Service Bulletin #3

CP300/400 SERVICE NOTES

Noise Blanker Modification (CP-300/CP-400):

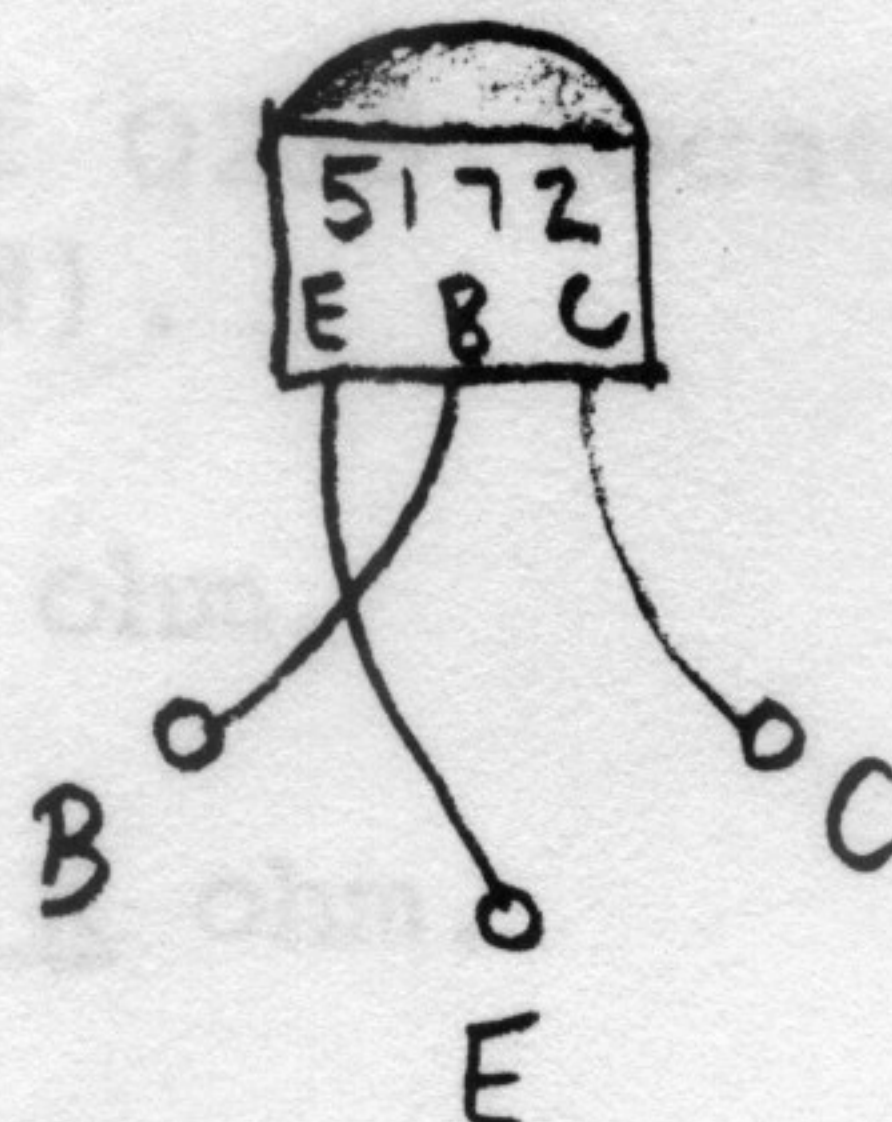
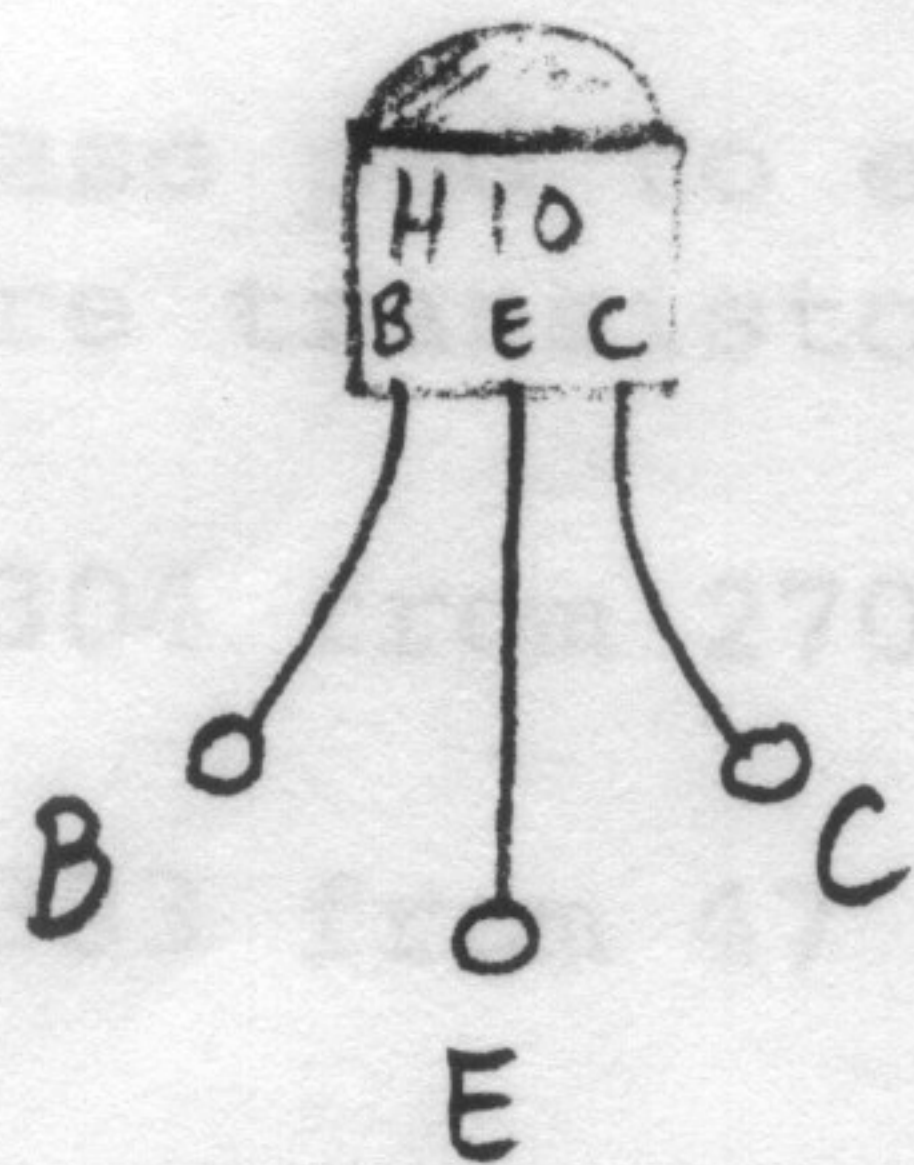
The following Modification is designed to improve the sensitivity and performance of the noise blanker. It is incorporated in all CP-400 shipped after May 1, 1977.

1. Locate four shield cans comprising front end of receiver (directly behind crystal filter). Remove two cans towards front of radio, L211 and L214 on layout in manual.
2. Replace Q224 on RT Board with MPS 5172. Note that the emitter and base are reversed as compared to the H10. See drawing.

3. Replace C297, 5pf disc with 2 pf disc. This capacitor is next to L214.
4. Reinstall cans.
5. Peak receiver per alignment procedure in service manual.
6. Tune Noise Blanker on 23.5 MHz, rather than 24.5 MHz as called for in manual.
